SUBJECT: Velan Swing Check Valves

In accordance with 10 CFR Part 21, we are advising the NRC about two (2) malfunctions involving 4" swing check valves in the Shorham site and 6" swing check valves at the Sequoyah site.

SUBJECT: PART 21 REPORT FROM VELAN VALVE

FIGURE 2

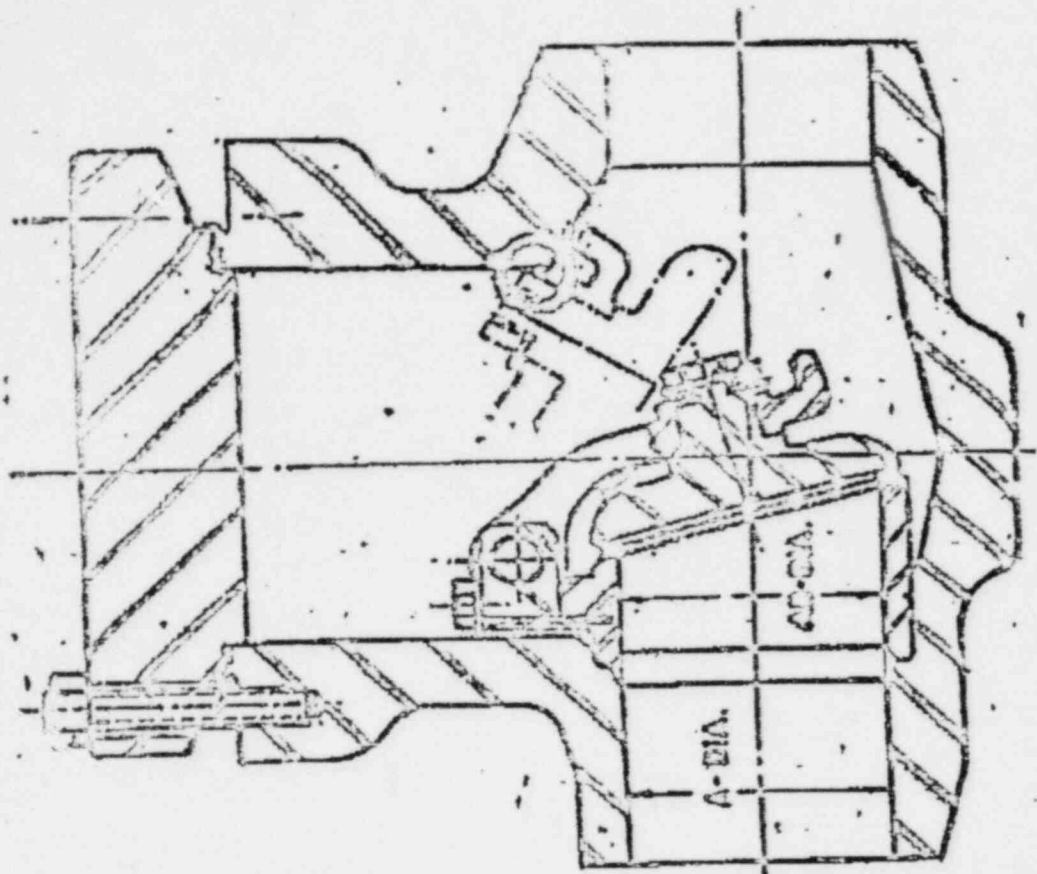
A 6" swing check hanger jammed in the open position due to a disc nut lock-wire jamming against a machined relief in the body (Fig. 2).

6" Valves: By re-orientating the lock-wire, the possibility of jamming is removed.

FIGURE 3

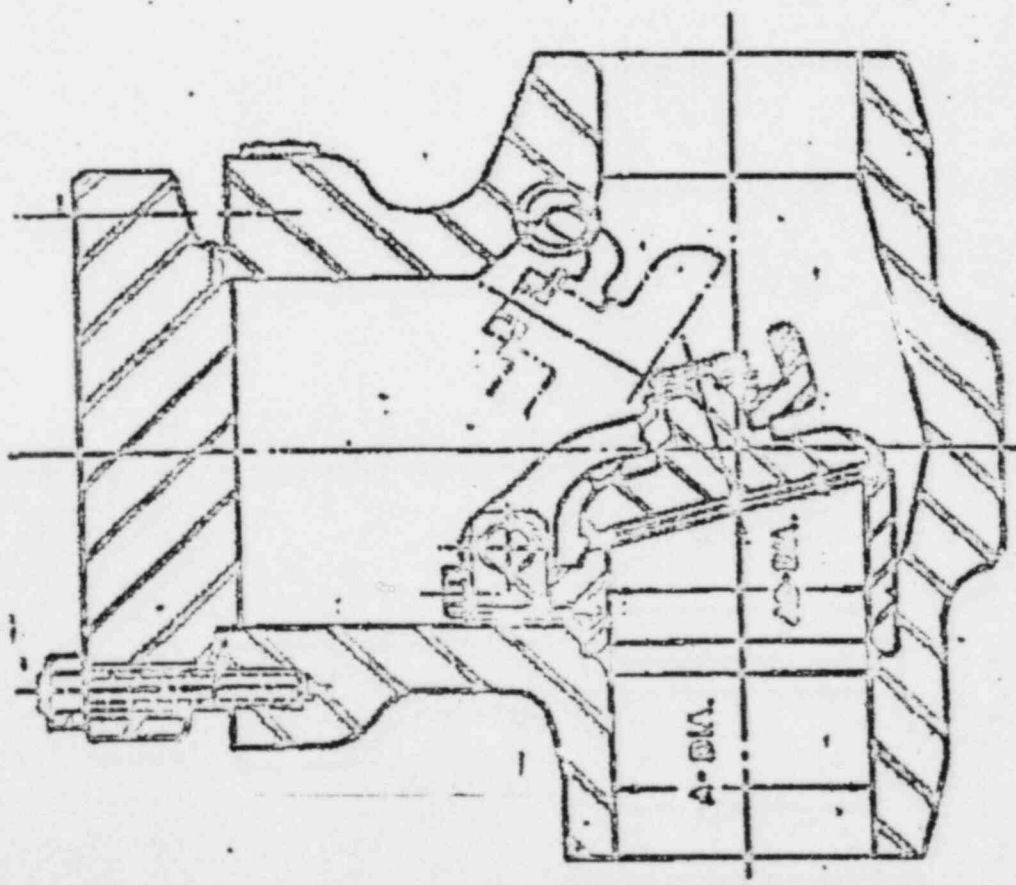
A disc hanger jammed in the open position, fouling a machined clearance in the body (Fig. 1).

4" Valves: Velan has supplied modified replacement hangers which preclude the possibility of jamming.
